CLIENT  
ZANCOR HOMES

PROJECT/LOCATION  
KING CITY  
KING CITY, ONTARIO

DRAWING  
SITE GRADING PLAN

REG. PLAN No.	65M-4295
ZONE	R4
LOT NUMBER	79
LOT AREA(m) <sup>2</sup>	N/A
BLDG AREA(m) <sup>2</sup>	N/A
LOT COVERAGE(%)	N/A
No. OF STOREYS	2
MEAN HEIGHT(m)	8.56
PEAK HEIGHT(m)	N/A
DECK LINE(m)	N/A

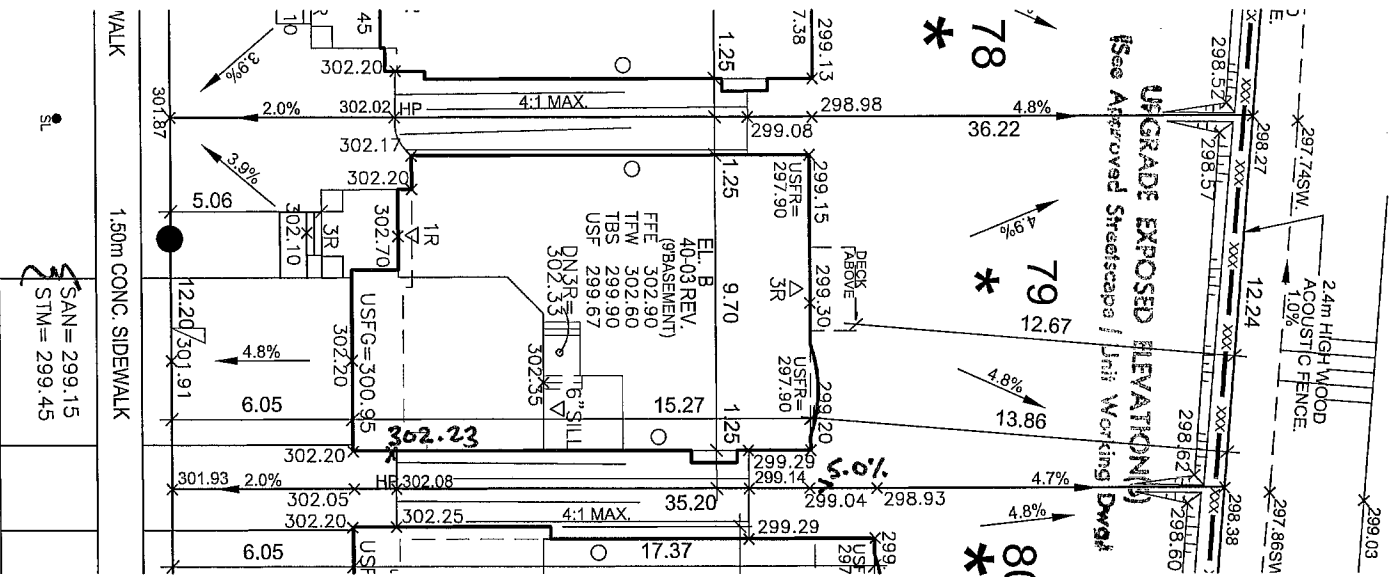
BURNSIDE & ASSOCIATES LIMITED  
 This plan has been reviewed with respect to general  
 conformance with the overall lot grading plan only and our  
 approval on this plan is for no other purpose.  
 We accept no responsibility for the accuracy of elevations and  
 dimensions provided by others.  
☐ REVIEWED WITHOUT CHANGES  
☒ REVIEWED AS NOTED ~~NOTES~~  
☐ REQUIRES RE-SUBMISSION  
 Reviewed by *[Signature]*  
 Date *March 2013*  
 R. J. Burnside & Associates Limited

REVIEWED AS NOTED  
ZONING BY-LAW 74-53 AS AMENDED  
DATE: March 18/13  
REF. APPL. NO. 2013-0114  
K & C (84)  
TOWNSHIP OF KING

NOTES:  
ALL STAIRS ACCESSING FRONT  
ENTRY TO BE POURED-IN-PLACE  
PER SEC. 4.4 FOUND IN KING NORTH  
// KING DUFFERIN / KINGSHIRE  
ESTATES
